ANA Garrison at Kunduz Does Not Meet All Quality and Oversight Requirements; Serious Soil Issues Need to Be Addressed

SIGAR Audit-10-09

SUBJECT: USACE Response to Special Inspector General Draft Report for Afghanistan Reconstruction SIGAR audit 10-09, Contract Performance Oversight, ANA Garrison at Kunduz Does Not Meet All Quality and Oversight Requirements; Serious Soil Issues Need to Be Addressed.

Figure 2: Master Plan of Kunduz ANA Garrison, Phase I

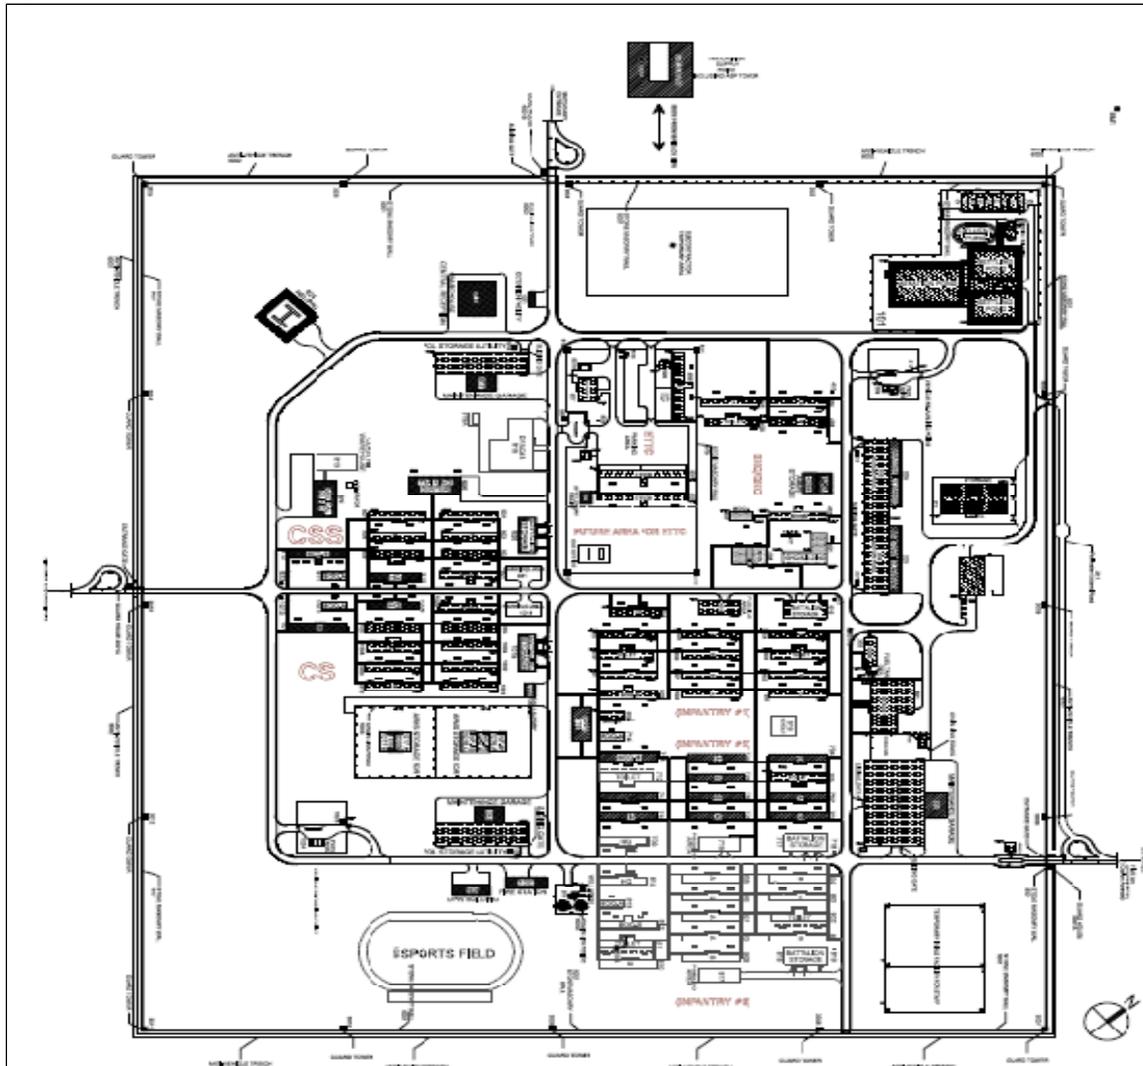
"As shown in figure 2, the master plan details two phases"

The diagram does not show Phase I and Phase I. Recommend replacing Figure 2 with the diagram that depicts all phases.

5. We modified the report to indicate that the diagram shown in figure 2 does not show Phase II of the Kunduz ANA garrison.
6. We modified the report to indicate that current plans call for housing German soldiers at the embedded training team compound.

Photo 2: Rust on Steel Supports at Kunduz ANA Garrison

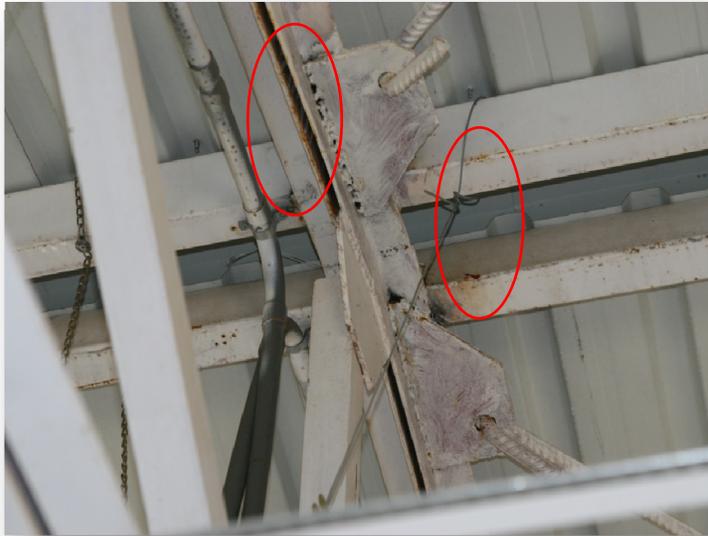
We observed that rust was breaking through the coat of primer that covered the sway bracing and the roof purlins¹⁰ at various locations. Oxidation or rust occurred because the primer coat had been applied too thinly and moisture had formed on the exposed steel. As a result, rust will damage the structural integrity of the steel. At some point, the roof may sag or collapse. See photo 2 for an example of rust on the structural steel.

1. Repair the welds and mitigate the rust on steel supports on the affected structures; and
2. Resolve the soil stability issue and determine what mitigation or corrective actions are required for DynCorp to complete the garrison, including ensuring that the site is properly graded.

USACE Response: CONCUR. The weld and rust problems, prior to the SIGAR project assessment, were identified through onsite quality assurance inspections. Corrective actions are in place and completed as described in further detail below.

a. The senior Quality Assurance Representative (QAR) at the Kunduz Resident Office discovered through direct visual inspections that the rust spots were primarily caused by various sections of the roof not being in place during heavy rains in December 2009 (the SIGAR was briefed regarding this issue during the site assessment). As briefed to the SIGAR on-site team, the QAR indicated that the USACE and the contractor were aware of the deficiencies, and when weather permitted, corrective actions were being affected.
